Road Safety Audit (Stage 2 Preliminary Design)

MPark - Road 22, Talavera Road, Macquarie Park, NSW

for Stockland Corporation Limited

**Re: M_Park Road 22 Talavera Road Macquarie Park
Response to Road Safety Audit Findings**

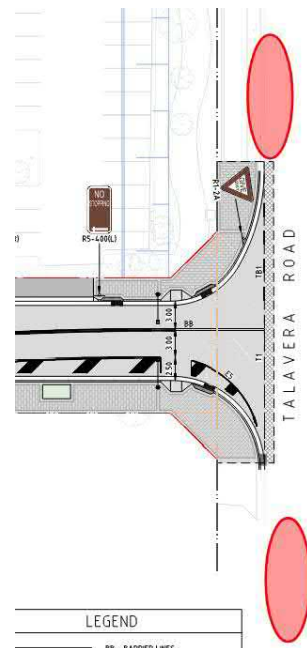
Audit Findings	Notes	Frequency, Severity = Risk Rating	Project Manager/ Asset Owner	
			Accept: Yes/ No	Reasons/ Comments
1. Left turn vehicle template impacts parking lane on Talavera Road. (Rear end and Side swipe collisions).	<p>The proposed new intersection and turning paths indicate a 12.5m HRV will use the outside parking lane to access Talavera Road. It is noted that the parking lane on Talavera Road is open to parking only between 10am and 3pm Monday to Friday. If the shown 12.5m vehicle is operating within these times, it is likely to clash with parked vehicles.</p>  <p>It is unclear if the above turning template can turn left into the outside lane and maintain lane discipline. It appears left turns that are avoiding parked vehicles are likely to cross the Talavera Road centre line and increase head-on collisions.</p>	Probable, Minor = High

Audit Finding Item Number	Design Engineer Response
1	Left hand turn template is to demonstrate a 12.5m HRV can make the turn when the parking restrictions are in force. The red zone shown on the diagram is actually the separation of the two west bound lanes and not the centreline. A 12.5m HRV can turn into the furthest westbound lane without crossing the centreline.
2	No Stopping zones on Talavera Road can be introduced to prevent parking and improve SISD. This can be incorporated at the detail design phase.
3	The pavement markings were introduced to show vehicles the best alignment when entering Road 22. The line markings can be deleted to reduce or negate the risk of vehicle / pedestrian collisions. This can be amended during the detail design phase.

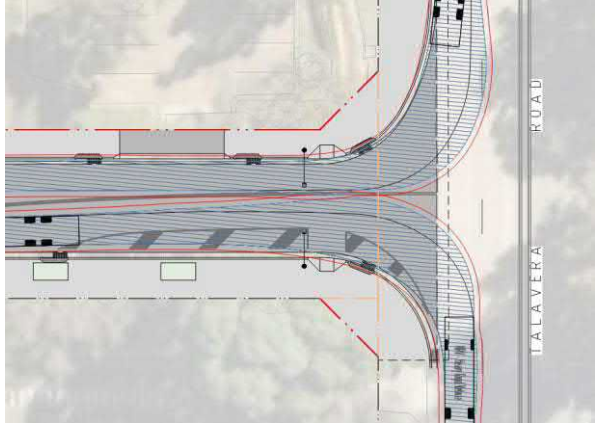
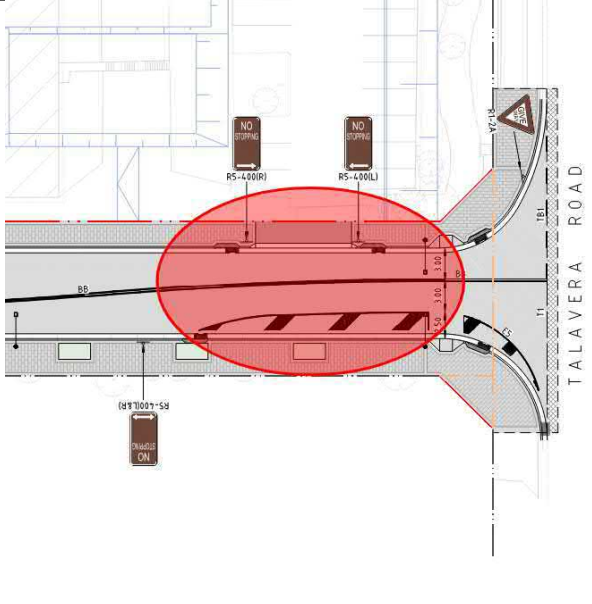
2. Parked vehicles either side of Intersection obstructing Sight Distance and exit movements. Potential Side Swipe and/or T-Bone Collisions

The drawings do not provide clarity to the allowance of right turn movements onto Talavera Road. It is understood that right turns may not be permitted and therefore only the on-street parking located to the east of Road 22 will impact Safe Intersection Sight Distance (SISD) and lead to sideswipe or T-bone collisions.

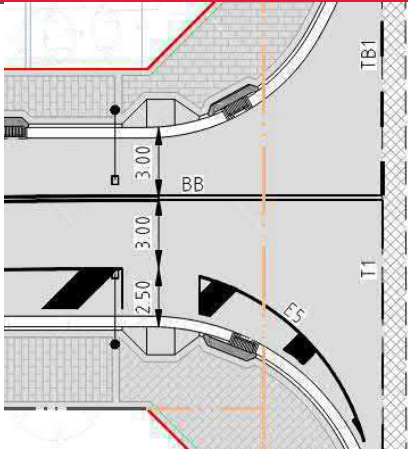
Audit Findings	Notes	Frequency, Severity = Risk Rating	Project Manager/ Asset Owner	
			Accept: Yes/ No	Reasons/ Comments
3. Line marking suggests protected crossing refuge. Potential for vehicle/pedestrian collisions	<p>The proposed pavement markings would seem to indicate the existence of an on-grade pedestrian refuge/ pedestrian protection where the provided 12.5m HRV turning paths will use this area to access Road 22. It is also noted that the adjacent pathway is a shared path with high pedestrian/cyclist use.</p> 	<p>Probable, Serious = Intolerable</p>

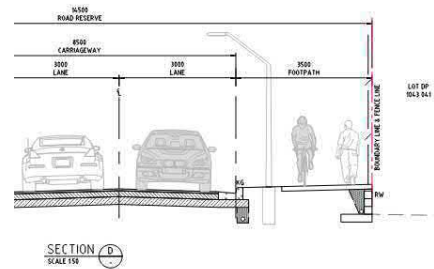
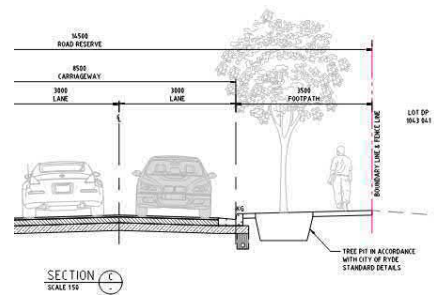
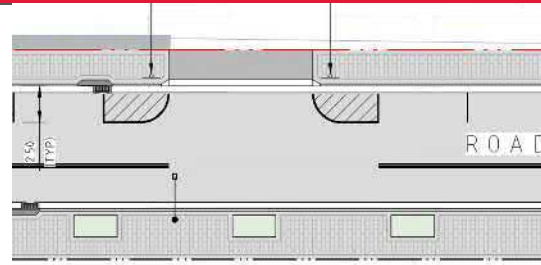
4. Proposed pram ramps locations do not align with shared path requirements.	<p>The proposed pram ramps do not appear wide enough to facilitate the existing cycle and pedestrian shared use. Also, the crossings appear located in a position that does not maintain the shared path's desire lines. This may lead to users avoiding the crossings and potentially tripping on the kerbs.</p>	<p>Probable, Minor = High</p>

5. Vehicle access into and from northern most driveway on Road 22. Potential Rear-end, T-bone and Head-on collisions	<p>On review of the turning templates, it is assumed that the nominal use for the site will be to provide access and egress for a 12.5m HRV. The location of the site's northern most driveway appears to create issues with right turn movements into the site (potential queue lengths onto Talavera Road) and left turn movements onto Road 22 from site (12.5m HRV would appear to cross the centre line).</p>	<p>Occasional, Minor = Medium</p>

4.	Pram crossings can be relocated closer to shared path desire lines. This can be amended during the detail design phase.
5.	The northernmost driveway has been provided for maintenance access only and will be used infrequently. When in operation the driveway will be used outside peak times and under traffic control.

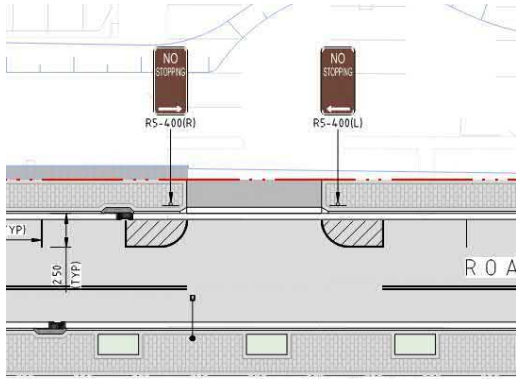
<p>6. Right Turn movements from site's middle driveway onto Road 22. Possible Rear-end, T-bone and Head-on Collisions</p>	<p>Reviewing the provided 12.5m HRV turning templates, it is understood that the proposed development will require access and egress by 12.5m HRVs. As such, the left turn movements by the HRV from the middle driveway appear as though they will cross the central Double Barrier line marking, increasing the risk for T-Bone and Head-on collisions.</p> <p>It is also noted that the 'No Entry' signage appear to be proposed in a location that is likely to reduce the sight line visibility of a truck exiting the site onto Road 22 further increasing the risk of collisions.</p>	<p>Probable, Minor = High</p>

6.	Passenger vehicles and HRV will cross the verge at approximately 30 degrees allowing the vehicle to access the kerb side lane without crossing the centreline. "No Entry" signage can be moved to within the property boundary to improve sight line visibility, The signage location can be updated during the detail design phase.

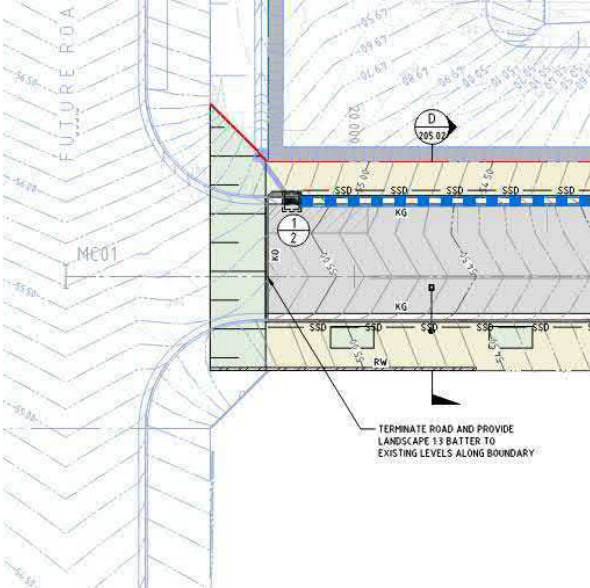
<p>7. Kerb inlet pits are very close to pram ramps. Potential for trip and slip hazards of pedestrians.</p>	<p>With close proximity of the pram ramps to proposed stormwater pits and unknown gutter flow widths, there is a chance that pedestrians may not use the pram ramp to access the footpath and therefore trip/ slip on the pit lintel causing injury. Gutter flow widths may not allow pedestrians and cyclists to use pram ramps without stepping into/ riding through deep flows.</p>	<p>Probable, Minor = High</p>

Audit Finding Item Number	Design Engineer Response
7.	The stormwater pit can be relocated away from the desire lines from the shared pathway and upstream of the relocated pram crossings avoid this risk. This can be updated during the detail design phase.

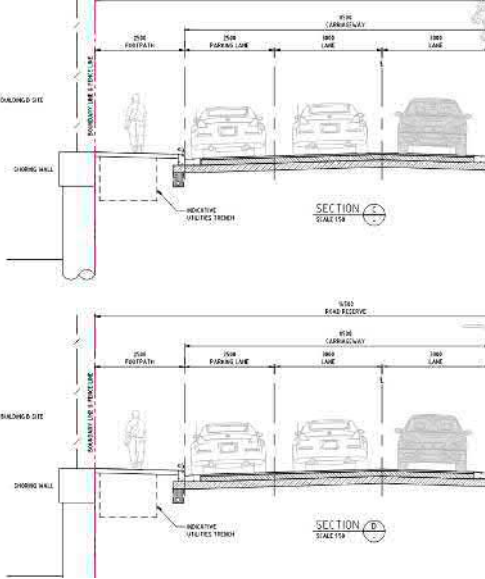
Audit Findings	Notes	Frequency, Severity = Risk Rating	Project Manager/ Asset Owner Accept: Yes/ No Reasons/ Comments
8. Landscaping/tree beds appear to provide narrow footpath width. Potential cyclists/pedestrian collisions	 <p>The landscaping/ tree beds on the design plans and typical sections appear to provide a very narrow footpath width to the outside of the proposed tree. Provided sections indicate the intended use of the path is to be a shared path. This narrower footpath section is likely to either direct cyclists or pedestrians into the trees of force the cyclists and pedestrians into the same footpath sections and therefore into conflict.</p>	Probable, Minor = High

8.	Tree pits shown indicatively at the concept design phase. Tree pits can be minimised in size to maximise shared pathway width. This can be amended at the detail design phase. We note that the general arrangement is in accord with Ryde Council's public domain manual.

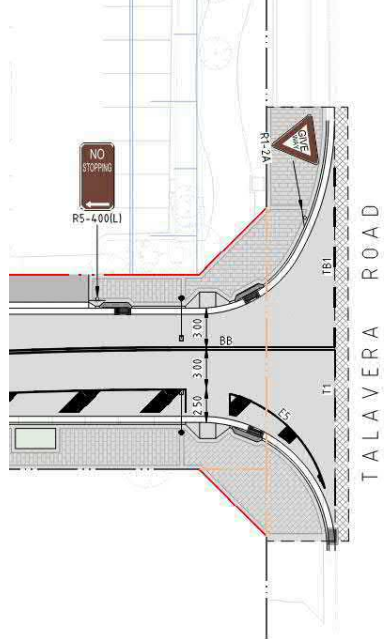
Audit Findings	Notes	Frequency, Severity = Risk Rating	Project Manager/ Asset Owner	
			Accept: Yes/ No	Reasons/ Comments
9. Left turn movements from site onto Road 22 crossing road centreline. Head-on and side swipe collisions.	<p>Signage indicates the southernmost driveway will allow entry and exit movements. Based on the turning paths provided (12.5m HRV) it is probable that the HRV will cross the centre line and increase the likelihood of head-on collisions</p> 	Occasional, Minor = Medium

10. Road 22 end treatment. No signage indicating 'No Through Road'. Potential confusion for drivers and 'U' turn restriction	<p>It is understood that Road 22 will form part of the public road network and will be temporarily terminated at the southern end of the proposed development. It appears future works will be to construct a new intersection at the southern end of the development.</p> <p>Safety concerns are identified around the lack of end termination at the Talavera Road intersection where road users may misread the intersection treatment and find themselves on Road 22 with no available room to turn around. This can lead to</p>	Occasional, Limited = Low

9.	The southernmost driveway has been provided for site ingress only. No vehicles will be leaving the site from this driveway.
10.	During the period where Road 22 terminates, provision for vehicles to turn around will be made just beyond the southern driveway. In this area signage and line marking will be provided to prevent parking within the turnaround area. "No Through Road" signage to be provided near the Talavera / Road 22 intersection. This can be updated during the detail design phase. During the period where Road 22 terminates infrequent traffic is expected on this road.
